TO: Kristopher Apanian, TAIT & Associates, Inc.
FROM: Amber Wood Hicken, Planner I
DATE: 6/3/25
SUBJECT: Parker Pointe, Auto Parts Store, Site Plan
Review Comments 02

O'REILLY AUTO PARTS PARKER, CO (PK2)

NEW O'REILLY AUTO PARTS STORE
STROTH RD
PARKER, CO #2
SITE PLAN COVER SHEET

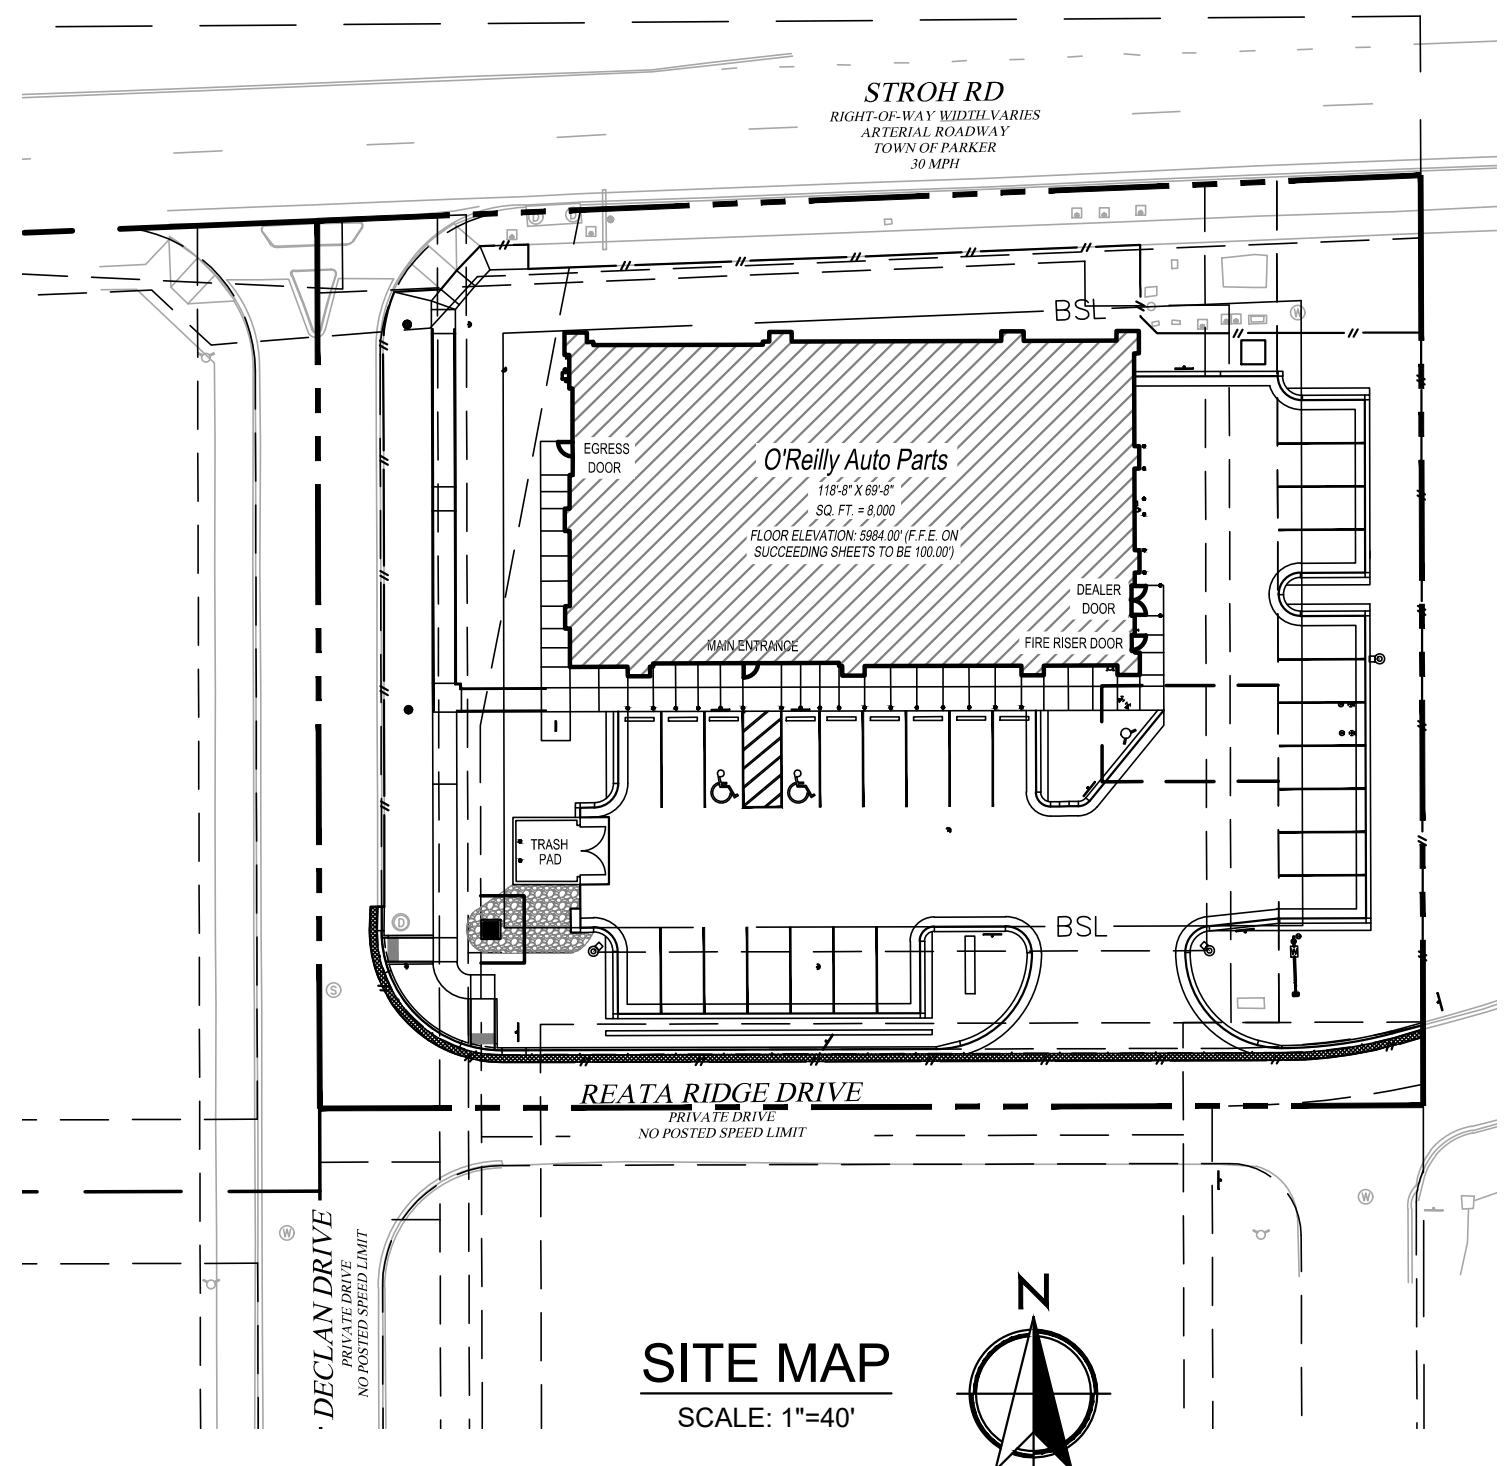
LS buffer info not needed on this sheet

add required/provided landscape (percentage and square footage)

TAIT Response: Added provided landscaping.

TAIT Response: Updated setback values.

TAIT Response: Removed

TAIT Response: Removed from cover sheet.
